DOWNTOWN DESIGN REVIEW BOARD

EARLY DESIGN GUIDANCE MEETING #2

600 WALL STREET

DPD# 3015251

SITE PLAN
REVISED DESIGN

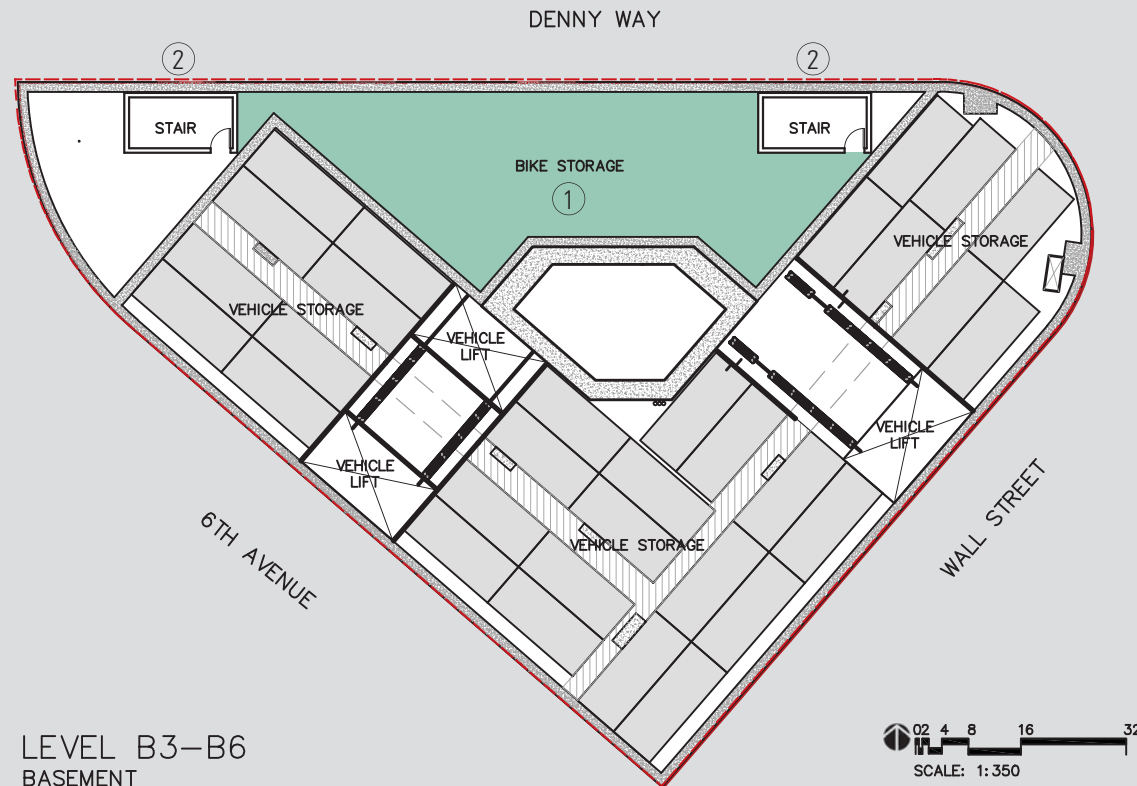
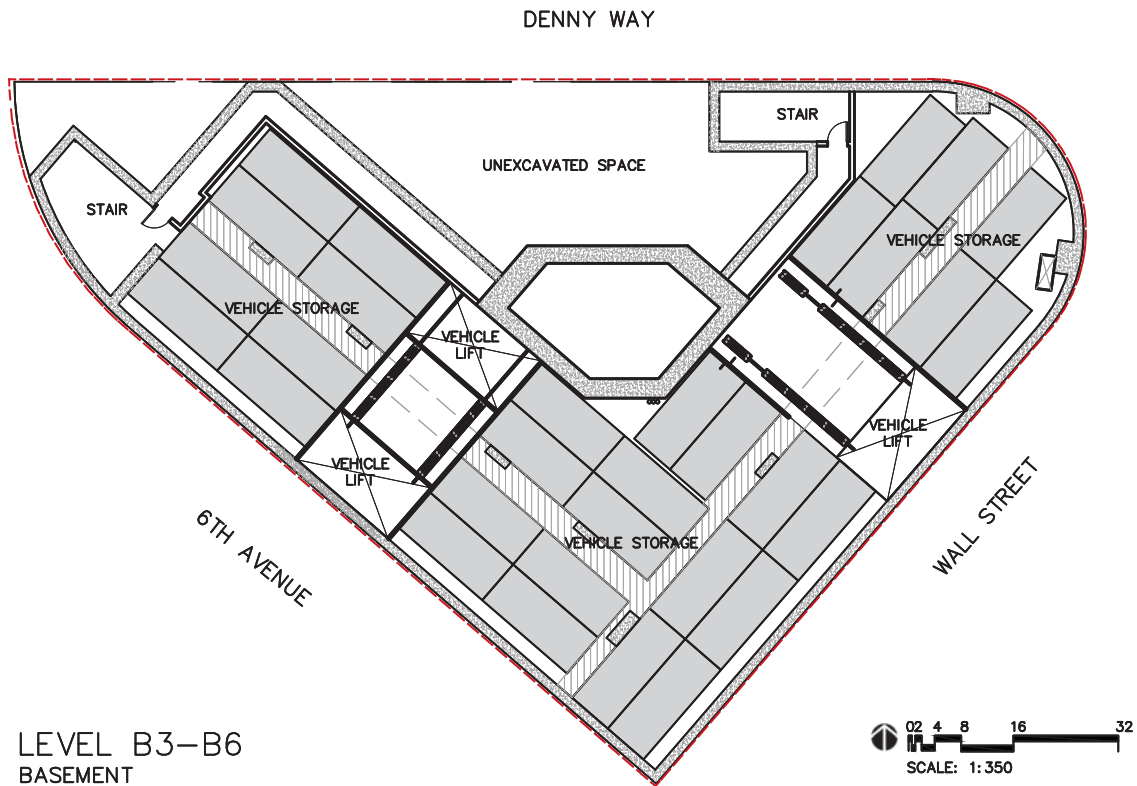
- SITE PLAN CHANGES
- 1. Revised Landscape Plan
 - 2. Revised curb layout per SDOT

LEVEL B3 - B7 CHANGES

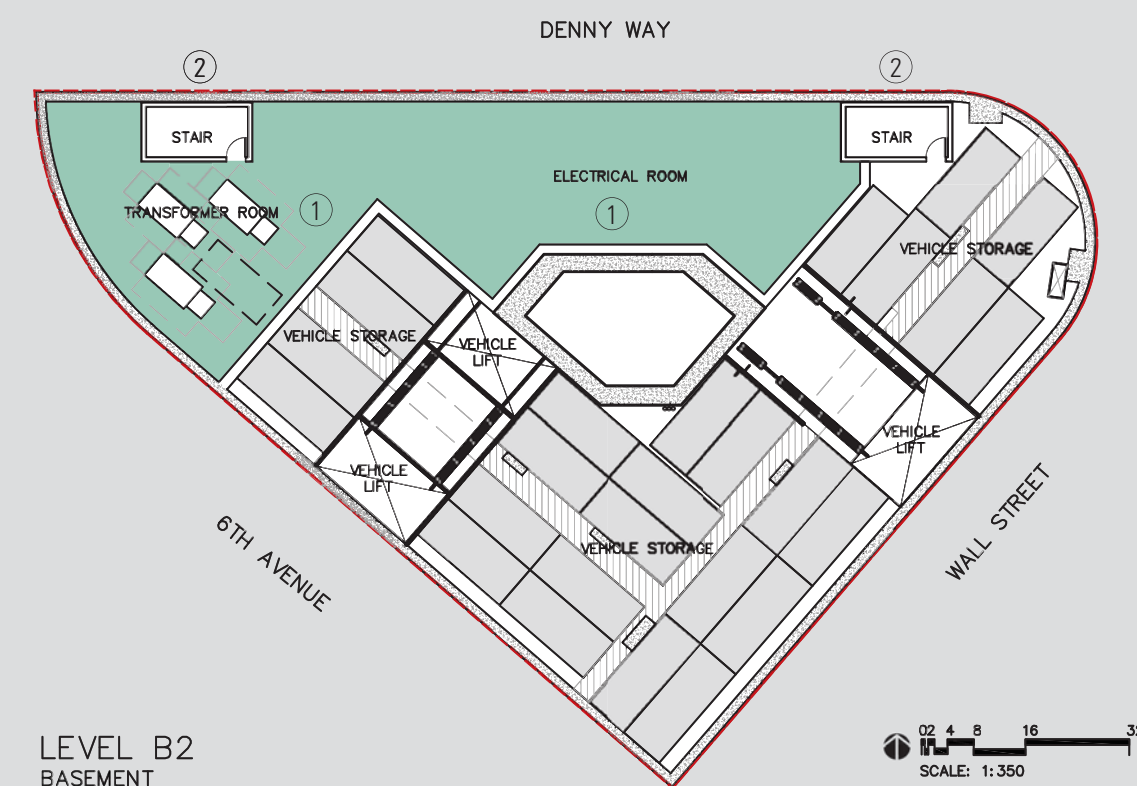
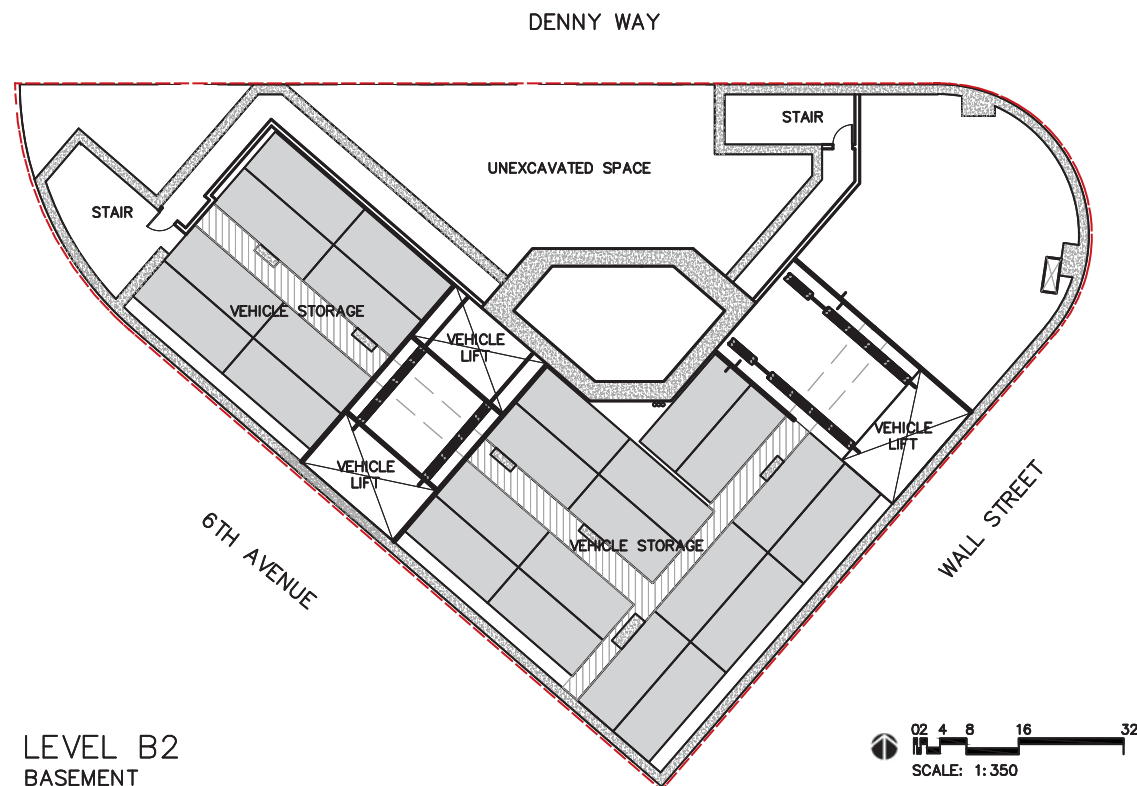
1. Added bike storage rooms
2. Relocated stairs

LEVEL B1
BASEMENT

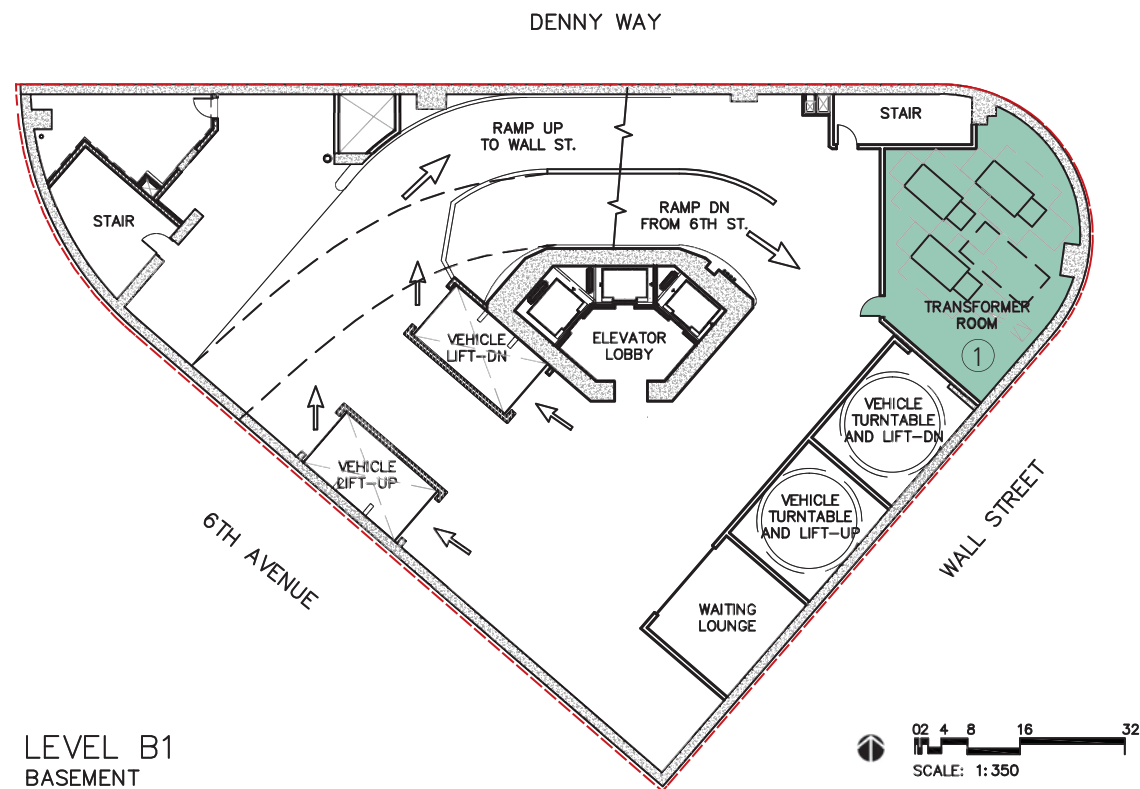
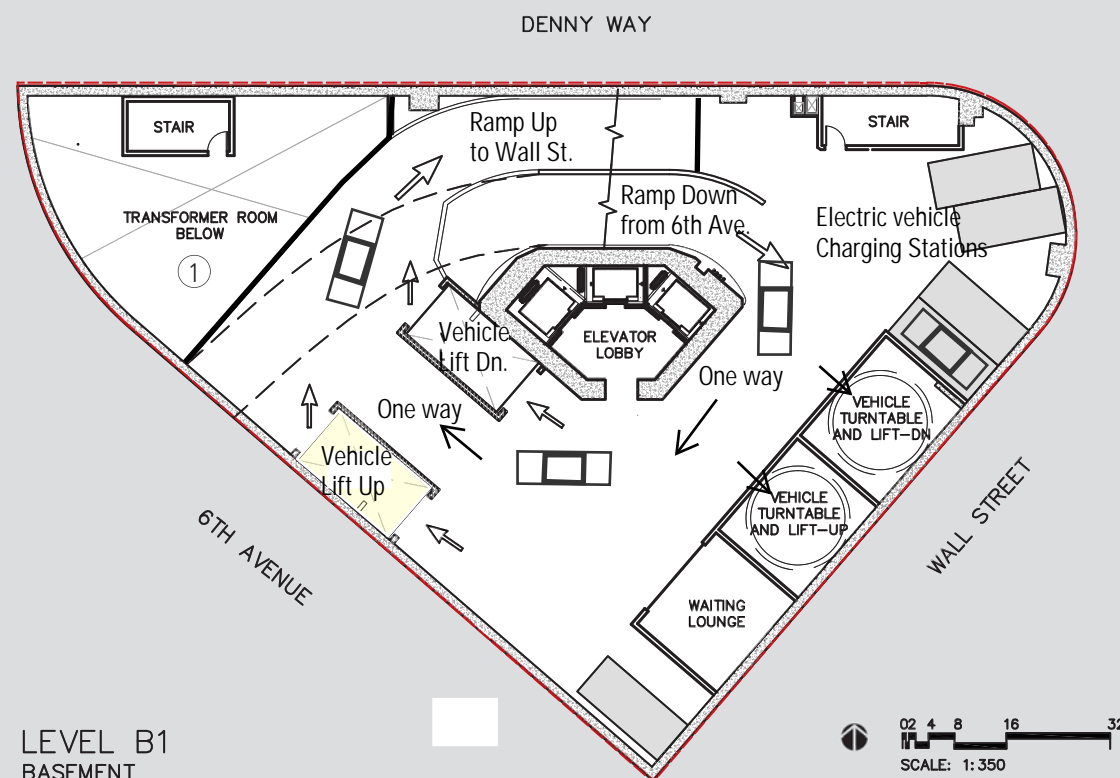
1. Relocated Transformer Room

LEVEL 01
STREET

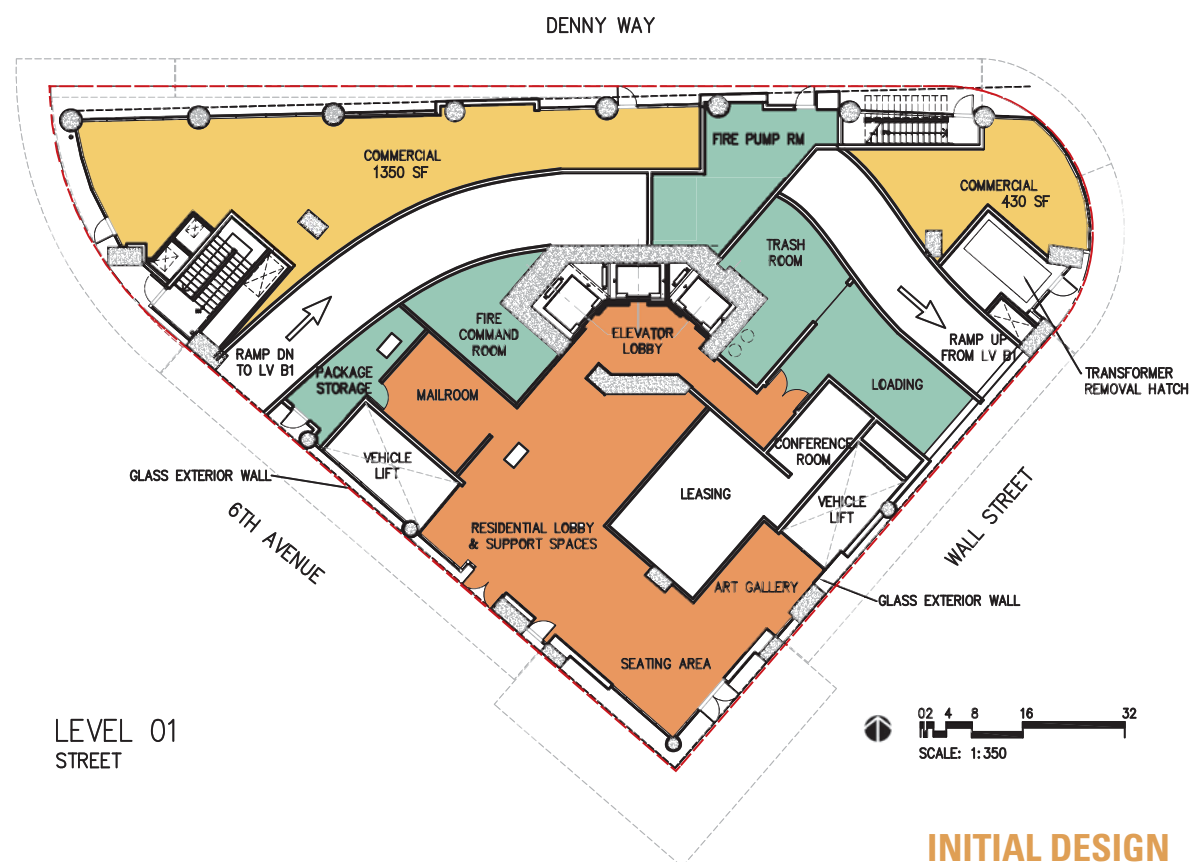
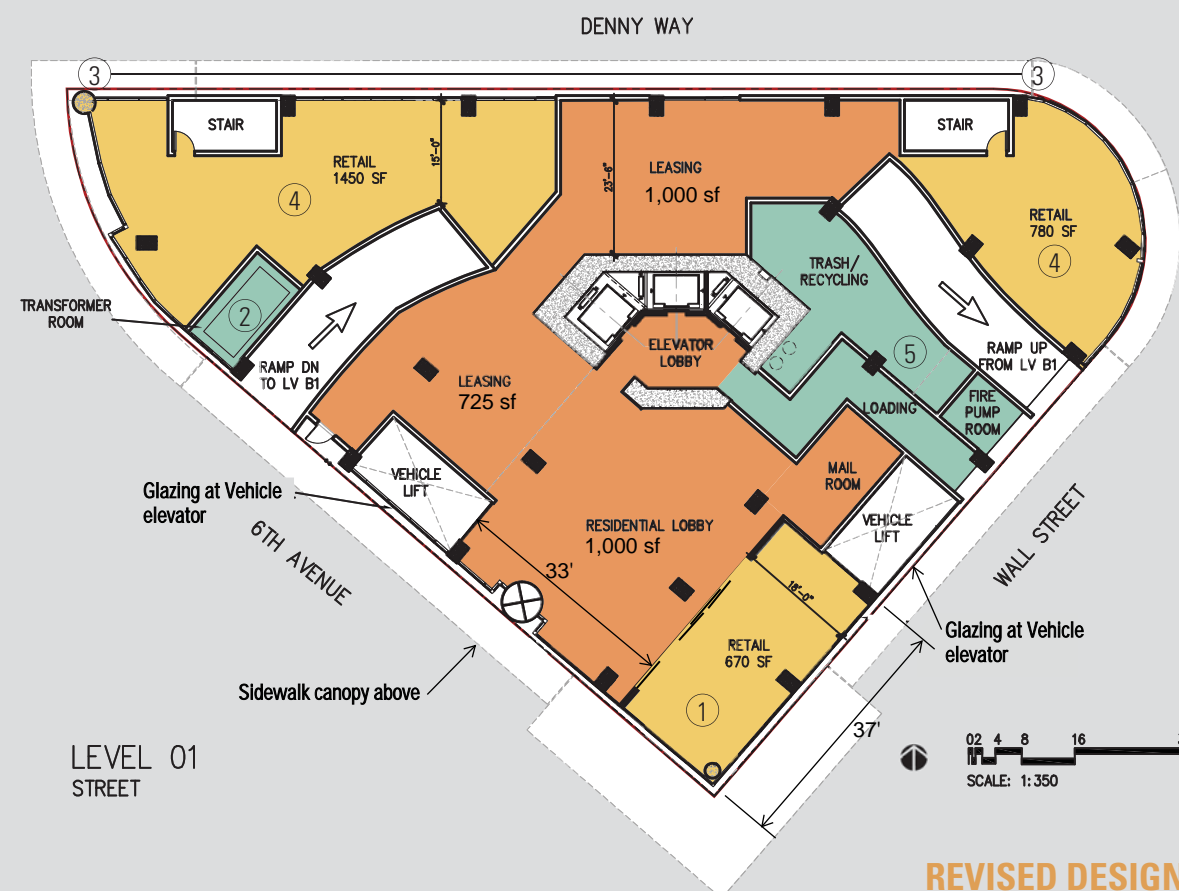
1. Added retail at Wall Street and 6th Avenue
2. Relocated transformer removal hatch to 6th Avenue
3. All street level uses on Denny Way are commercial/retail - thet spaces
4. Commercial spaces at corners have been reconfigured
5. Back of house support space has been reconfigured to minimize street frontage

LEVEL 04
PARKING

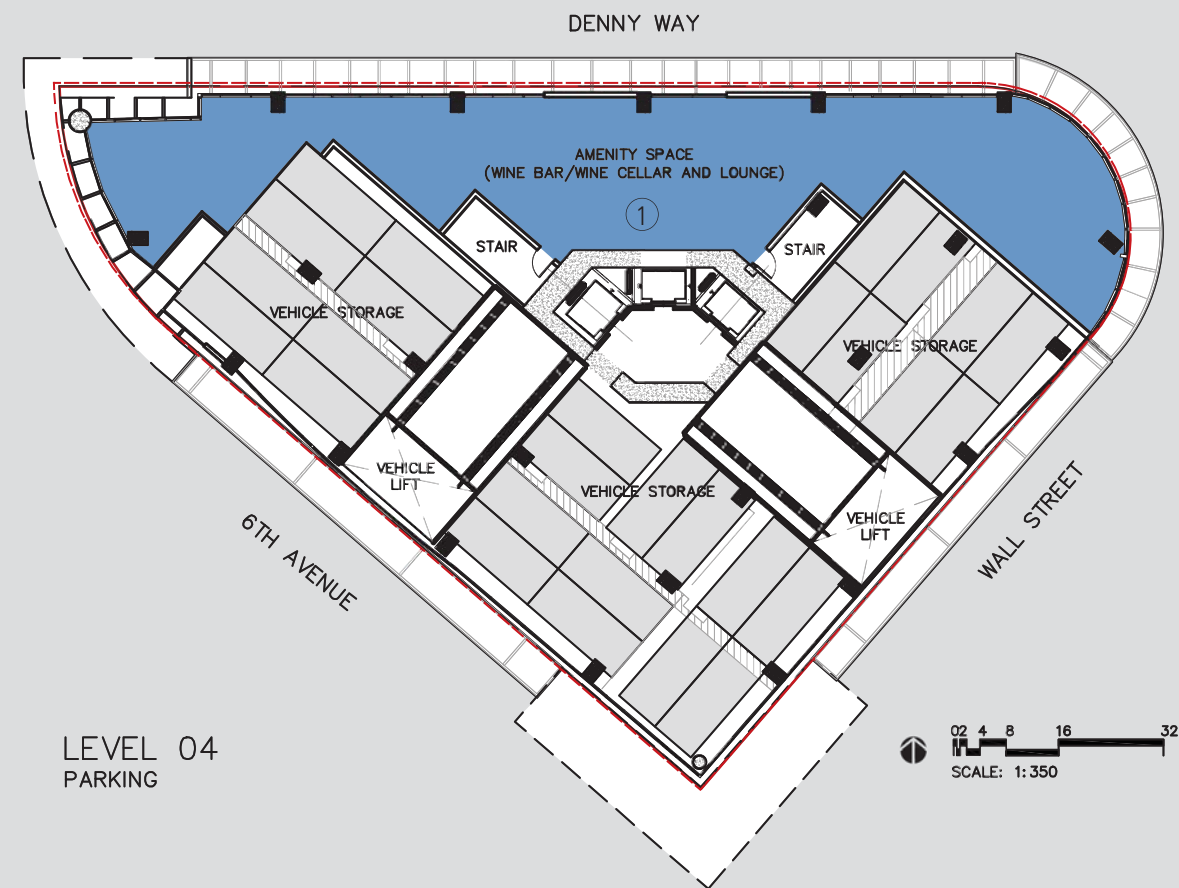
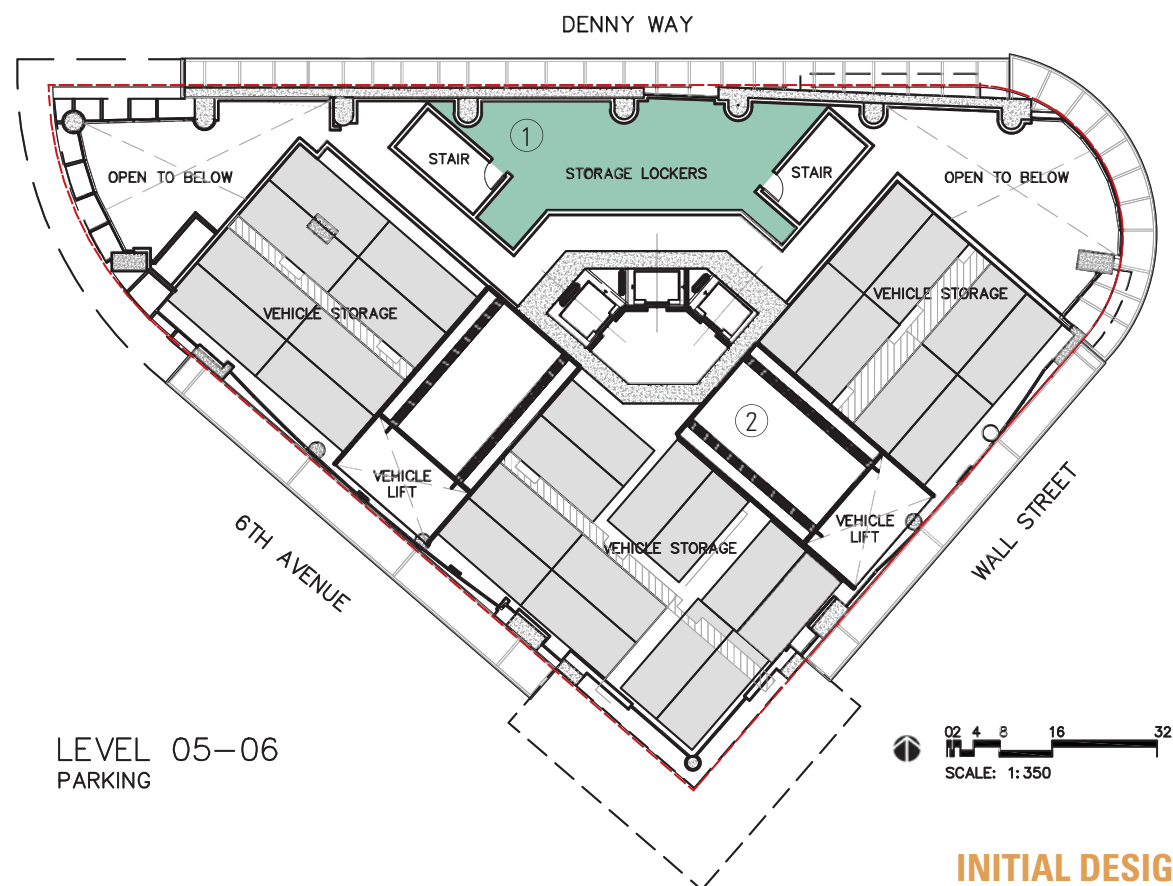
1. Storage area and art studios are converted to a wine bar/cellar and tasting rooms/lounge areas

LEVEL 05A/6
MEZZANINE

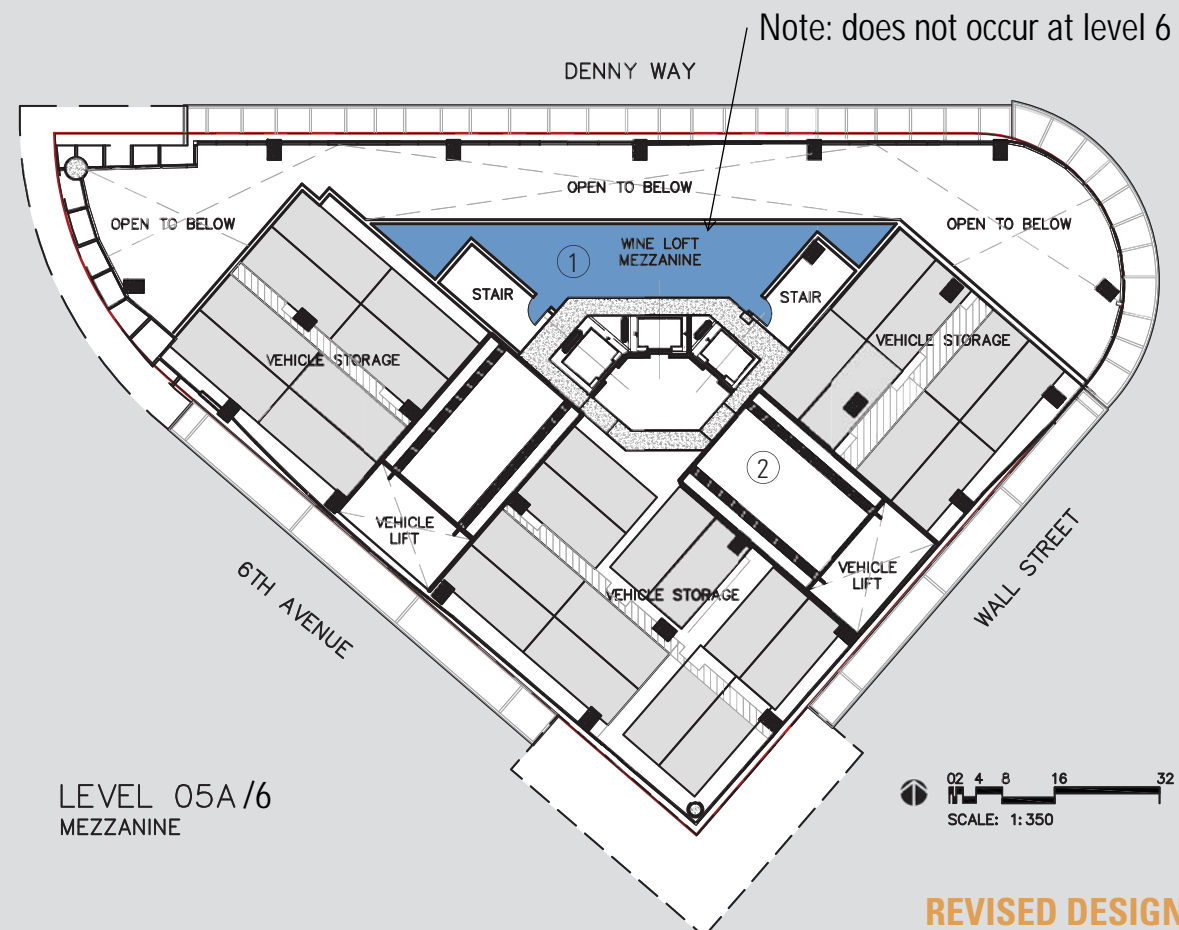
1. Private mezzanine area created in the Wine Loft area for private wine lockers
2. Levels 5 and 6 parking levels remain unchanged
